DEVELOPMENT APPLICATION ASSESSMENT REPORT

Application Number:	DA2024/1139
---------------------	-------------

Responsible Officer:	Jordan Howard
Land to be developed (Address):	Lot 6 DP 17127, 83 Crown Road QUEENSCLIFF NSW 2096
Proposed Development:	Alterations and additions to a dwelling house including a swimming pool and carport
Zoning:	Warringah LEP2011 - Land zoned R2 Low Density Residential
Development Permissible:	Yes
Existing Use Rights:	No
Consent Authority:	Northern Beaches Council
Delegation Level:	DDP
Land and Environment Court Action:	No
Applicant:	Matt Elkan

Figure 1 - Extract from Section AA depicting maximum building height (9.8m) and area above 8.5m height standard in red.

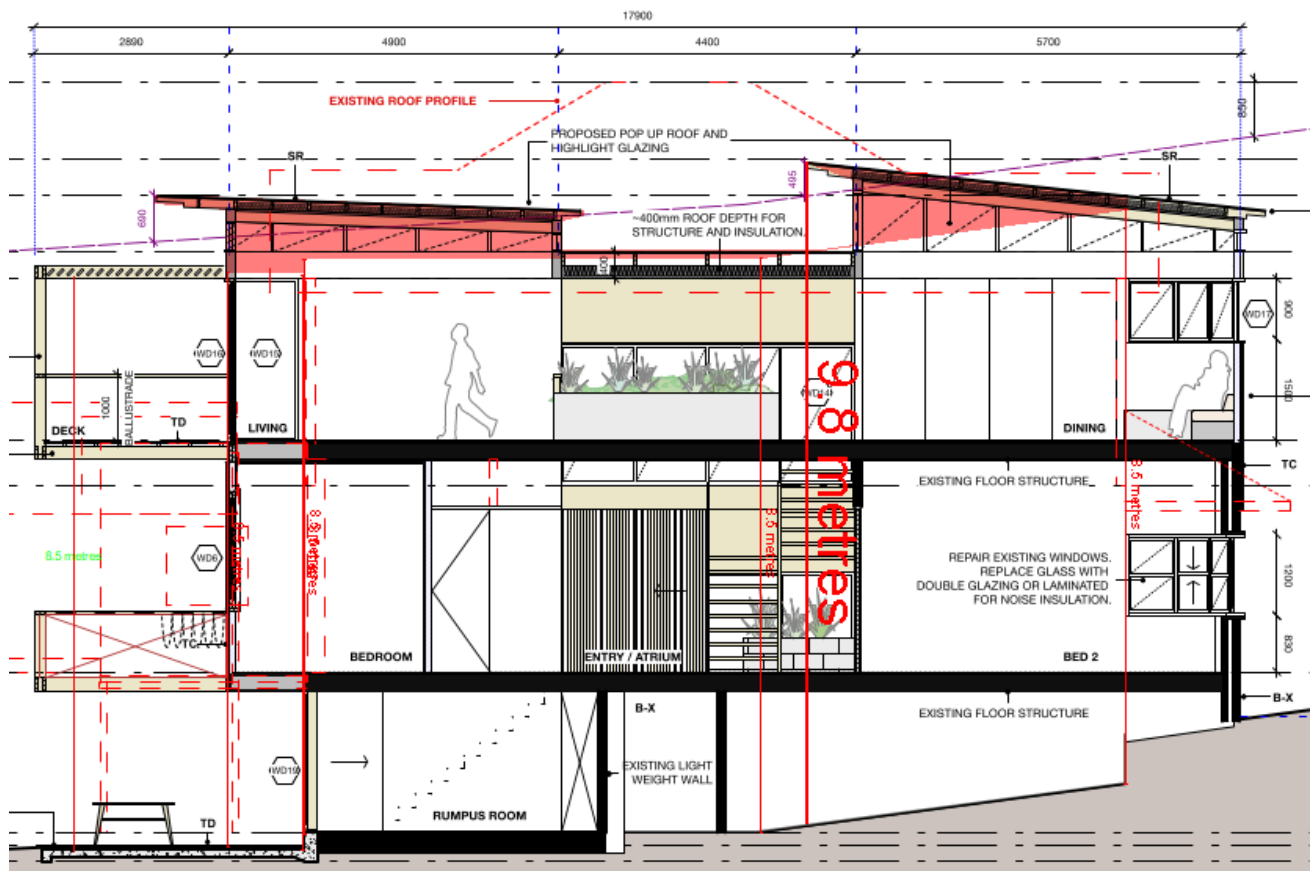
Proposed: 9.8m

Percentage of variation: 15.3%

- By renovating the existing roof form, the proposal reduces the bulk of the existing building and improves visual impact and solar access.
- Requiring further reduction to the proposed roof height would result in significant modification to the existing building (noting that the existing building is non-compliant with the development standard) and so result in an unreasonable reduction to the existing habitable floor area and thus impact the overall amenity of the residents.
- The proposal has been designed with articulated facades to minimise the visual bulk from the street and adjoining properties.

Council is satisfied that the Applicant has demonstrated that there are sufficient environmental planning grounds to justify the contravention of Clause 4.3 Height of buildings for the following reasons:

Figure 3 - Extract from Western Elevation with side boundary envelope encroachment in red.

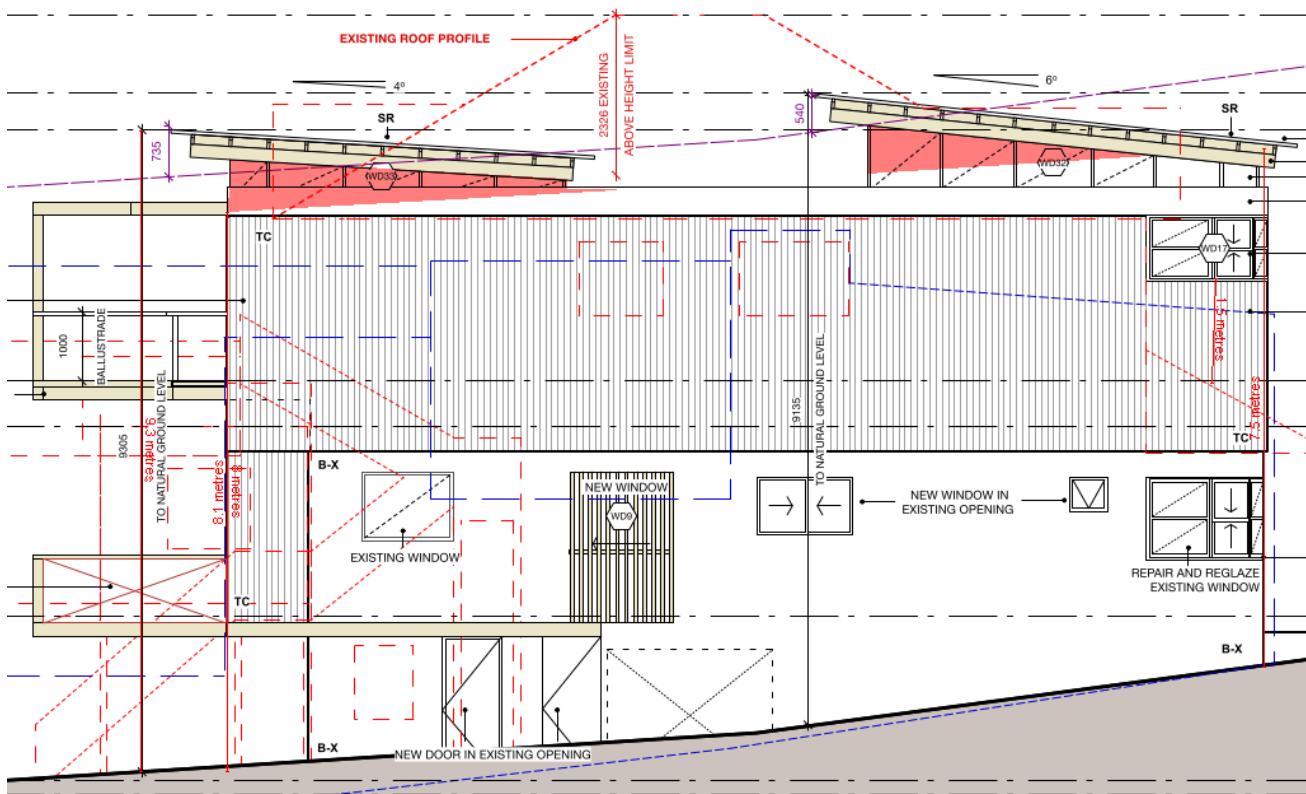
Built Form Control	Requirement	Proposed	% Variation	Complies
B1 Wall height	7.2m	8m	11.1%	No
B3 Side Boundary Envelope	East: 5m	Outside envelope (see <i>Figure 2</i>)	N/A	No
	West: 5m	Outside envelope (see <i>Figure 3</i>)	N/A	No

Notably, the proposal largely retains external walls, with portions of these breaches caused by existing walls to be retained. The parapets and pop-up skillion roofs are the proposed elements which breach the side building envelope.

Notwithstanding the variation, the proposed alterations and additions are well removed from adjoining properties, and provide fully compliant side setbacks to the dwelling house at both eastern and western side elevations. The breach is largely an existing one, occurring in part due to topography sloping down toward the northern end of the site, and due to the reuse / adaptation of an existing structure, with existing non-compliances. The changed roof design reduces bulk, height and scale by lowering the roof height overall, and breaking up the design of the roof with pop-up skillion roof segments. Overall, the proposed alterations and additions are considered to result in a dwelling commensurate to that of surrounding development and not visually dominant by virtue of its height and bulk.

Having regard to the above assessment, it is concluded that the proposed development is consistent with the relevant objectives of WDCP and the objectives specified in s1.3 of the Environmental Planning and Assessment Act, 1979. Accordingly, this assessment finds that the proposal is supported, in this particular circumstance.
